Recall Bulletin

PRODUCT SAFETY RECALL

SUBJECT: Transmission Oil Cooler Connection

MODELS: 2014 Chevrolet Silverado Light Duty Regular Cab, Double Cab, Crew Cab 1500 Series
2015 Chevrolet Suburban, Tahoe
2014 GMC Sierra Light Duty Regular Cab, Double Cab, Crew Cab 1500 Series
2015 GMC Yukon, Yukon XL
Equipped with 6-Speed Automatic Transmission (MYC)

3793000

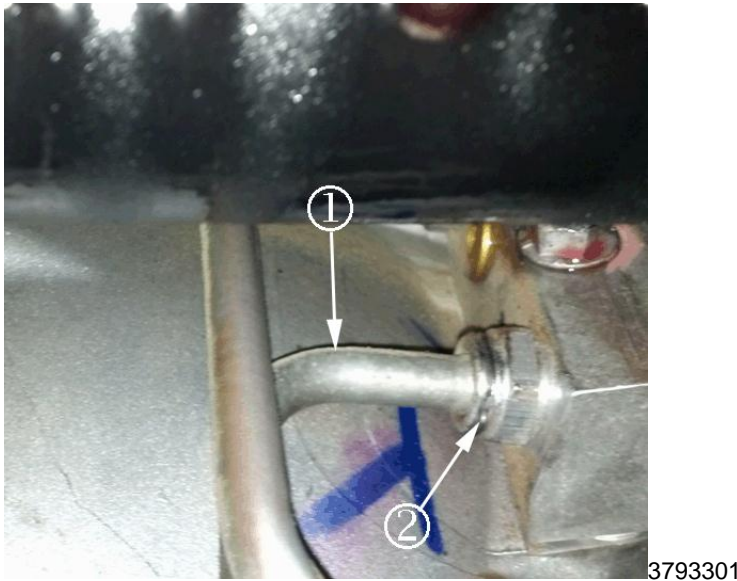
Photograph shows a fluid leak at the quick connect fitting (2) of the transmission cooler line (1) and thermal bypass valve (3).

2.2. Inspect the area around the thermal bypass valve (3) and the end of the transmission cooler line (1) for evidence of a fluid leak.

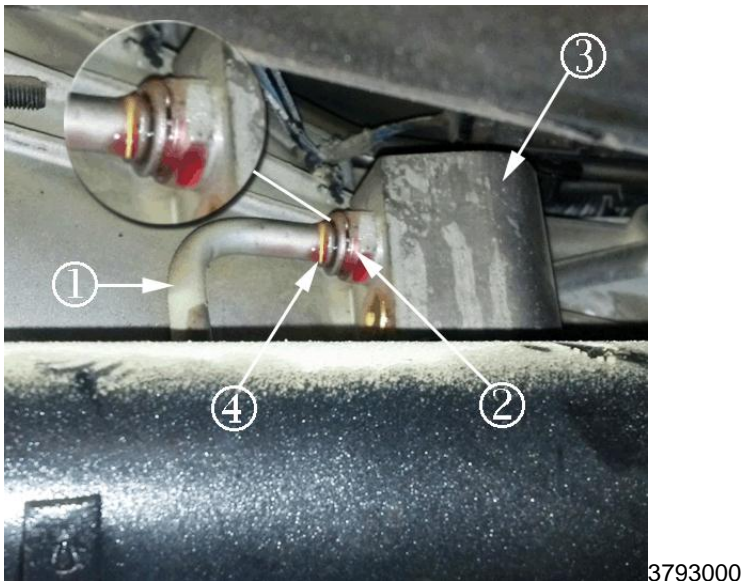
The transmission cooler line (1) is NOT fully seated into the thermal bypass valve. Notice that a yellow line (4) is present and there is evidence of a fluid leak.

Note: The yellow band should not be visible above the top of the fitting itself. If it is visible above the top of the fitting, then the pipe is not fully inserted and seated, refer to illustration.

- If a yellow mark (4) is present, remove and replace the transmission cooler line with a new line. Refer to *Transmission Fluid Cooler Inlet and Outlet Pipe Replacement* in SI.
